WPCP REHABILITATION PROJECT
PROJECT NO. 08-593-52-239

ADDENDUM NO. 4

March 30, 2011

SKETCH 4.01 - DRAWING 00-TM-02

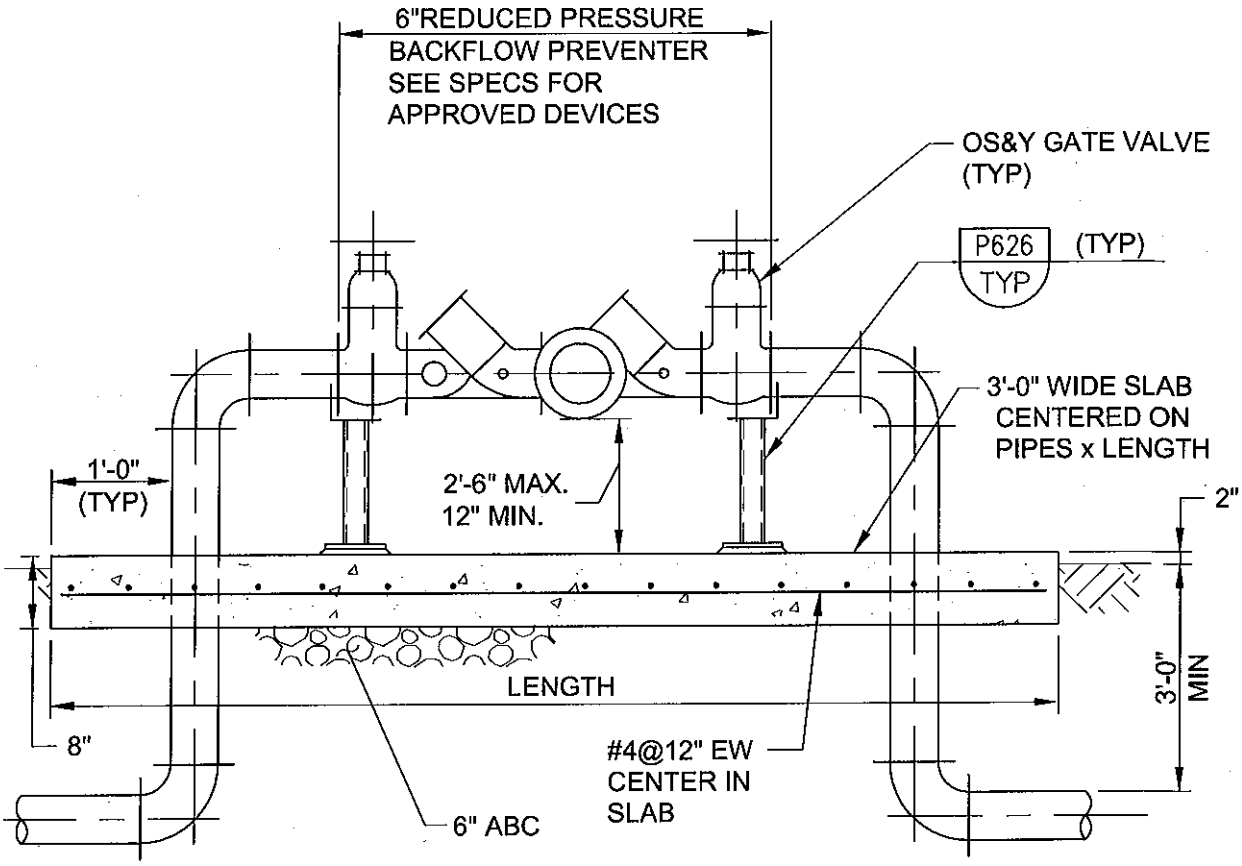
Item 4.56 **Drawing 00-TM-01** – Add typical detail M310 on attached Sketch 4.01.

SKETCH 4.02 - DRAWING 10-E-03

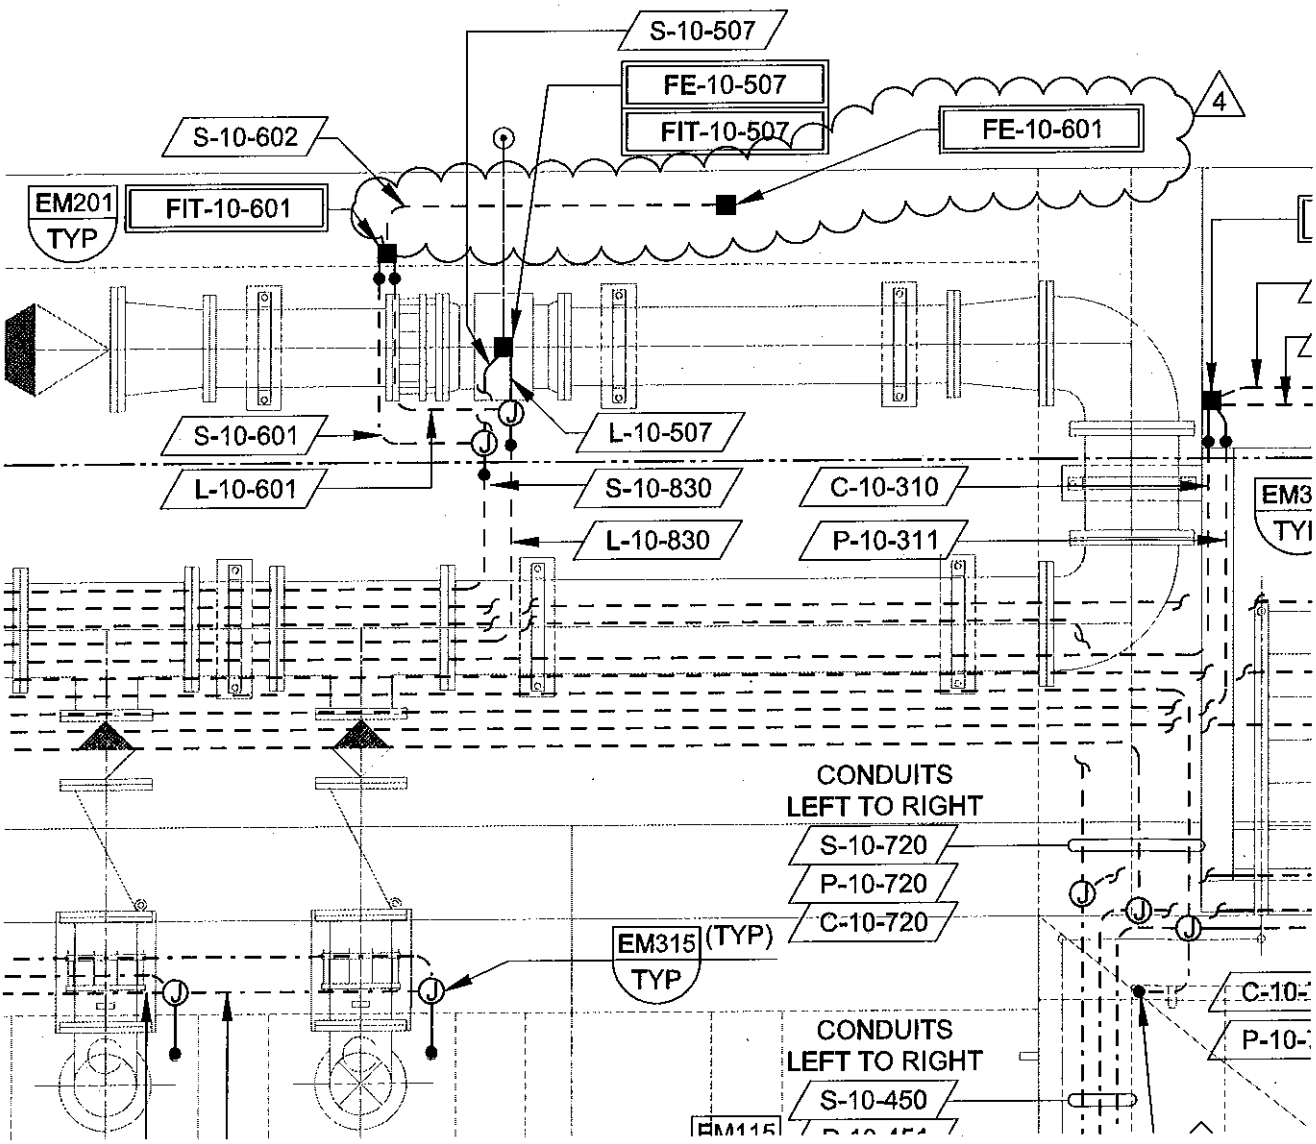
Item 4.79 **Drawing 10-E-03** – Revised drawing as shown on the attached Sketch 4.02.

SKETCH 4.03 - DRAWING 01-E-03

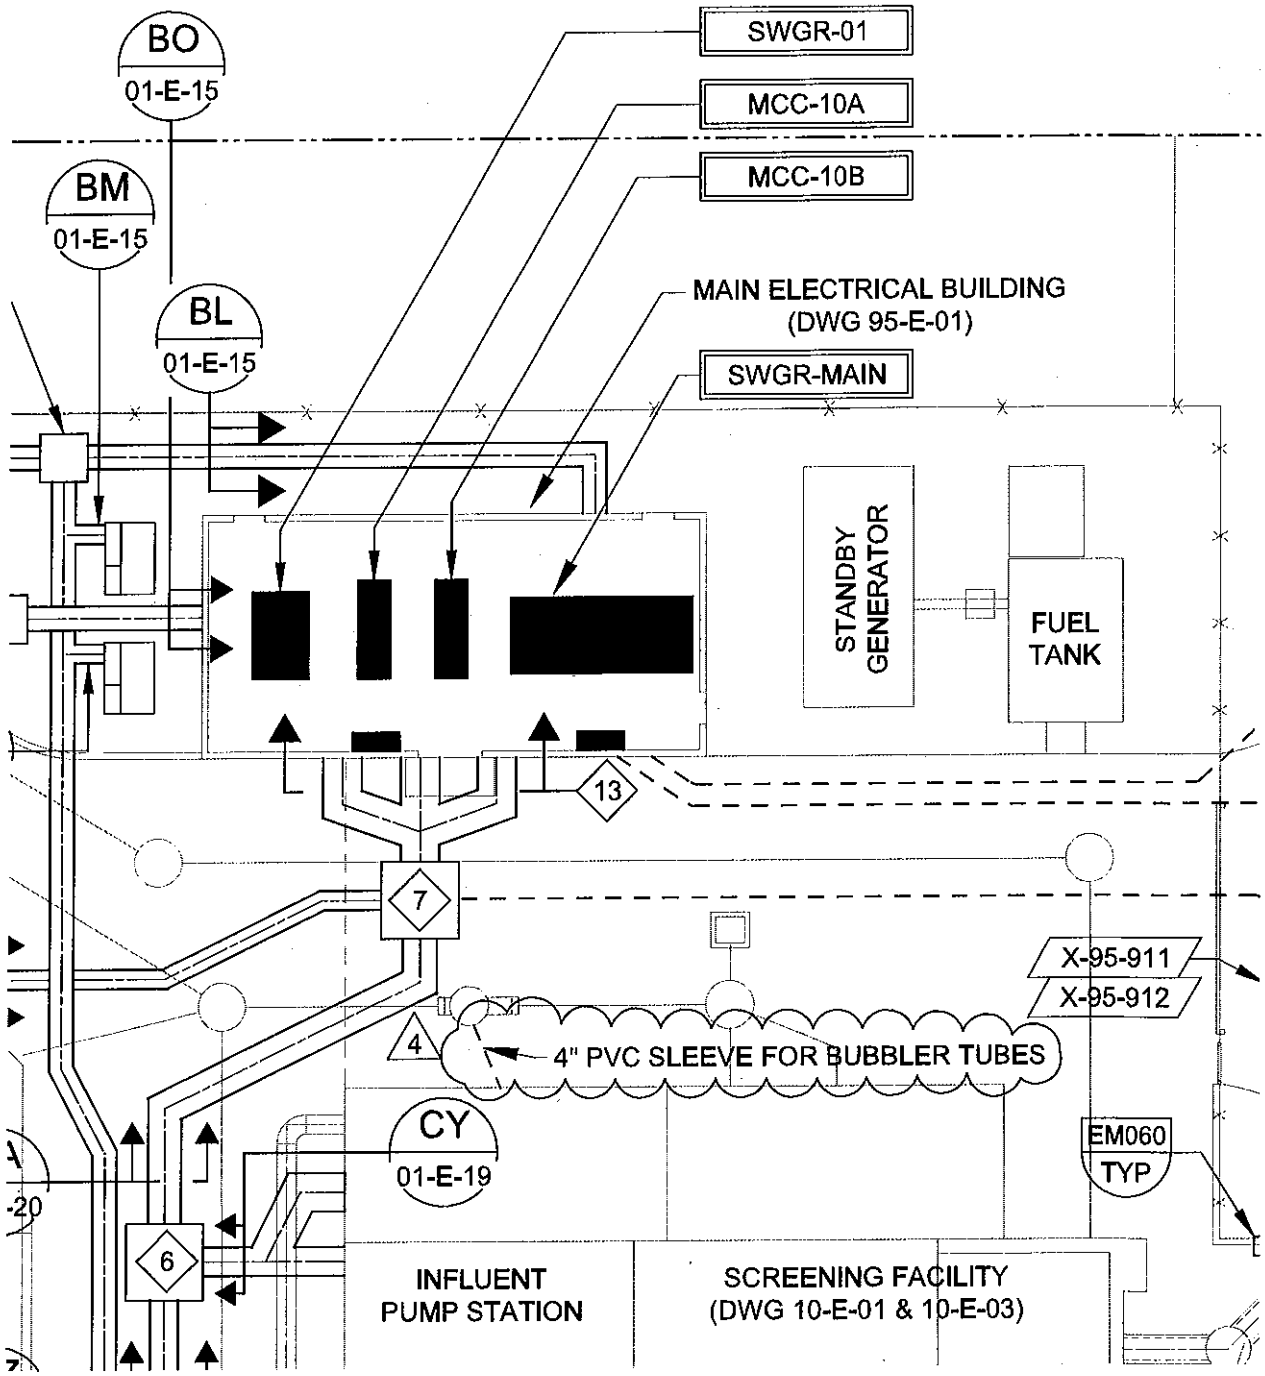
Item 4.78 **Drawing 01-E-03** – Revised drawing as shown on the attached Sketch 4.03.

Sketch 4.04 **Drawing 90-S-17, Detail 5**

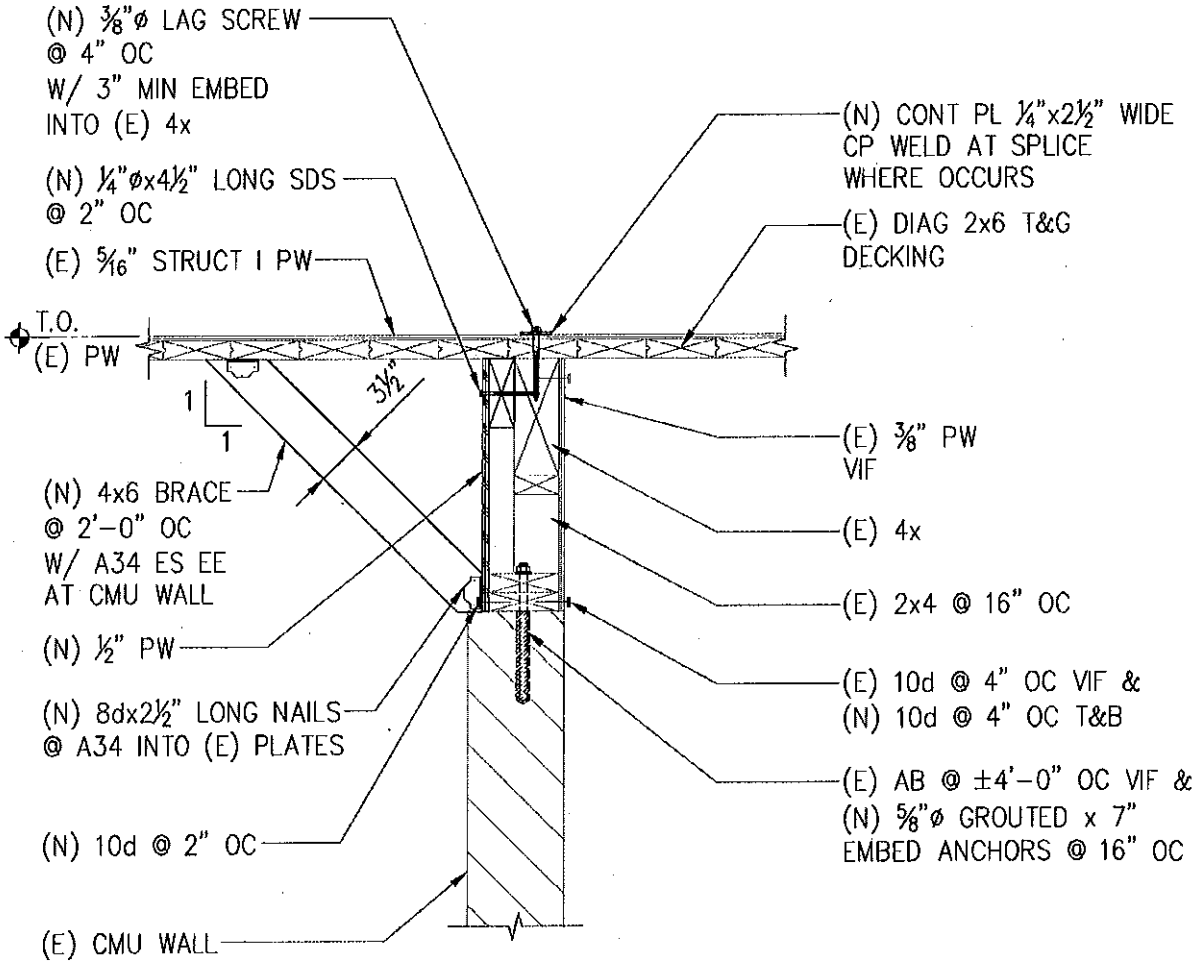
Item 4.102 **Drawing 90-S-17, Detail 5** - Delete Detail 5 and replace with the revised detail shown on the attached Sketch 4.04.

Sketch 4.05 **Drawing 90-S-18, Detail 7**

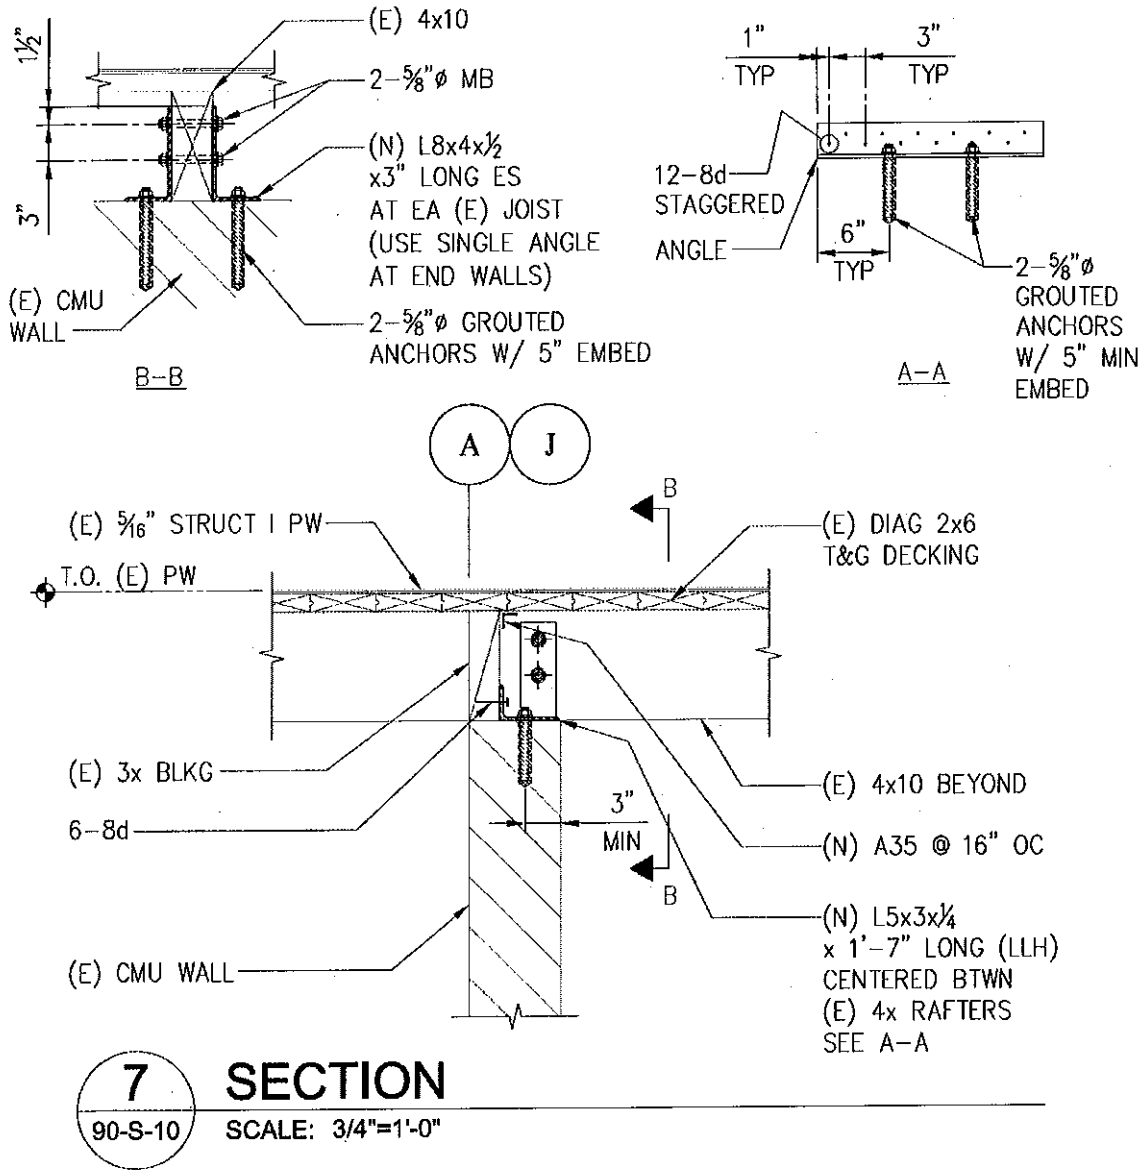
Item 4.103 **Drawing 90-S-18, Detail 7** -- Delete Detail 7 and replace with the revised detail shown on the attached Sketch 4.05.

Sketch 4.06 **Drawing 90-S-21, Detail 3**

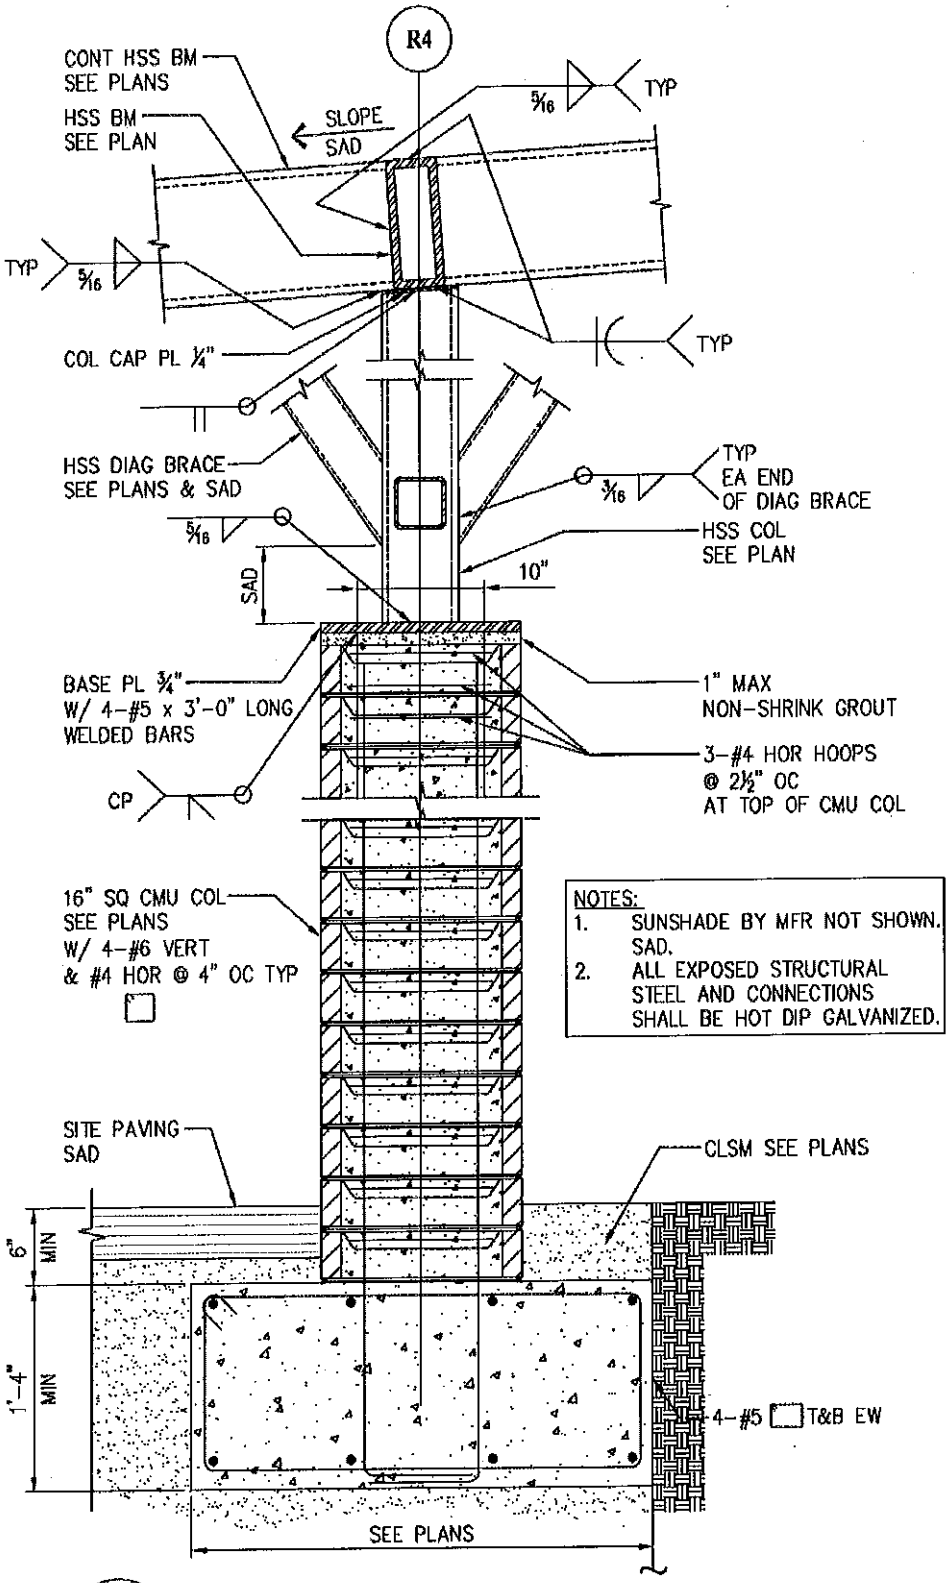
Item 4.105 **Drawing 90-S-21, Detail 3** -- Delete Addendum No. 1 Sketch 1.03 and replace with the revised detail shown on the attached Sketch 4.06.

SKETCH 4.07 - DRAWING 01-D-08

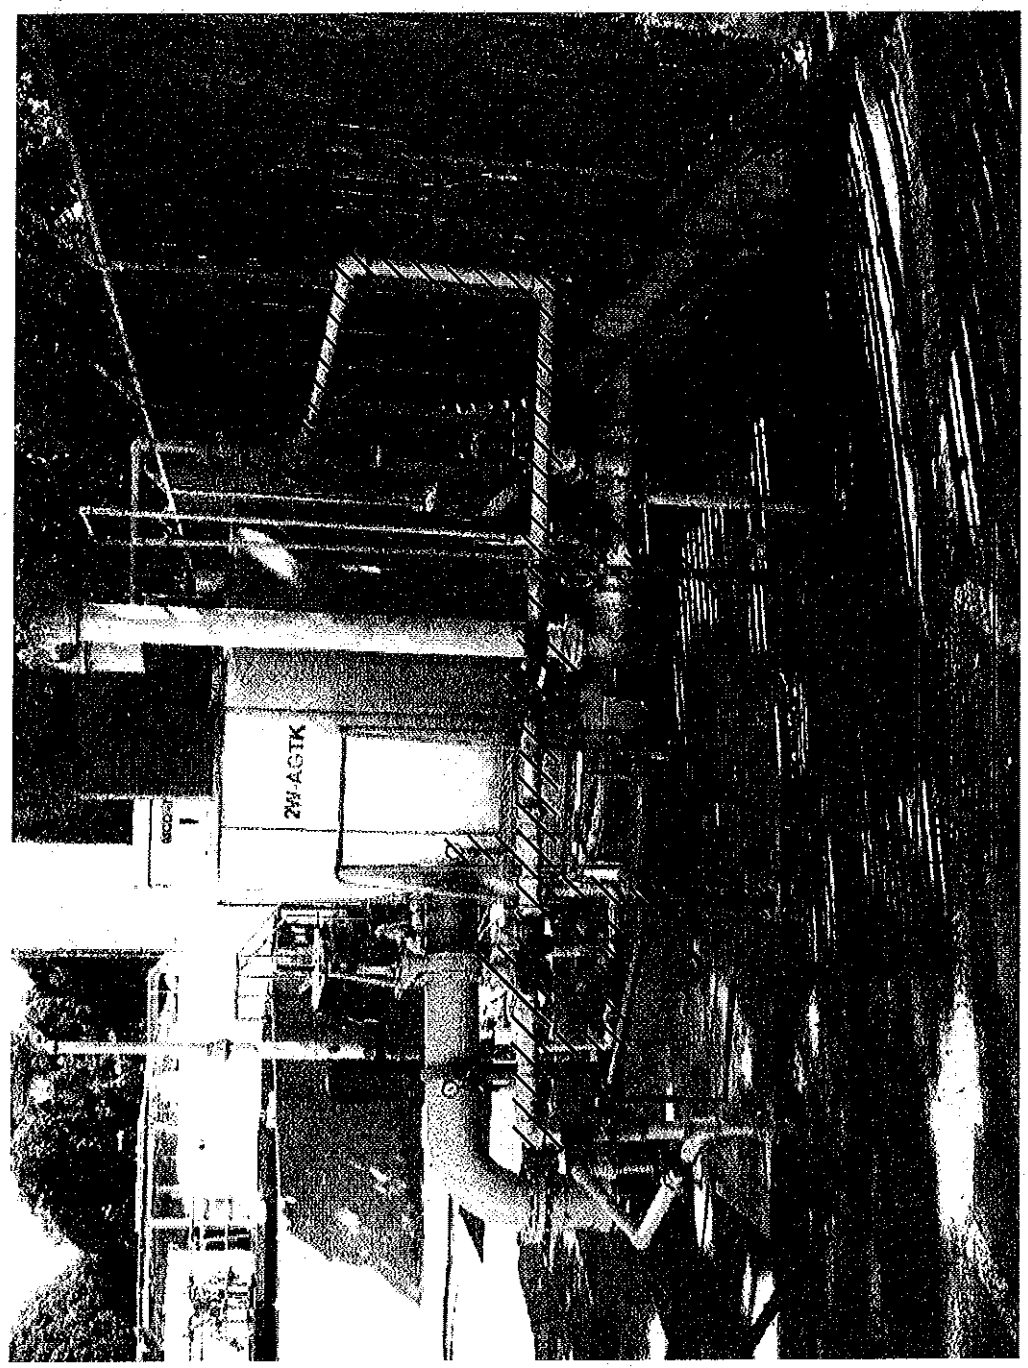
Item 4.57 **Drawing 01-D-08** – Add new Detail A/01-D-07A shown on attached Sketch 4.07.

SKETCH 4.08 - DRAWING 24-S-05

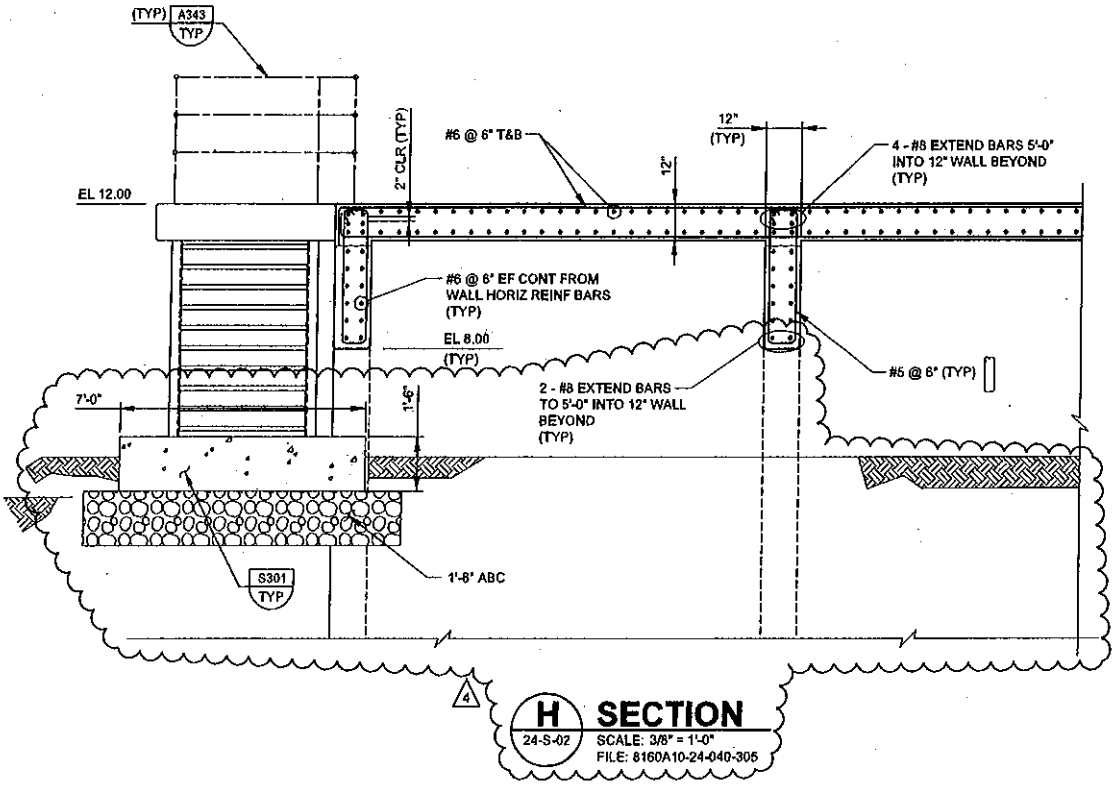
Item 4.74 **Drawing 24-S-05** – Revise Section H as shown on the attached Sketch 4.08.
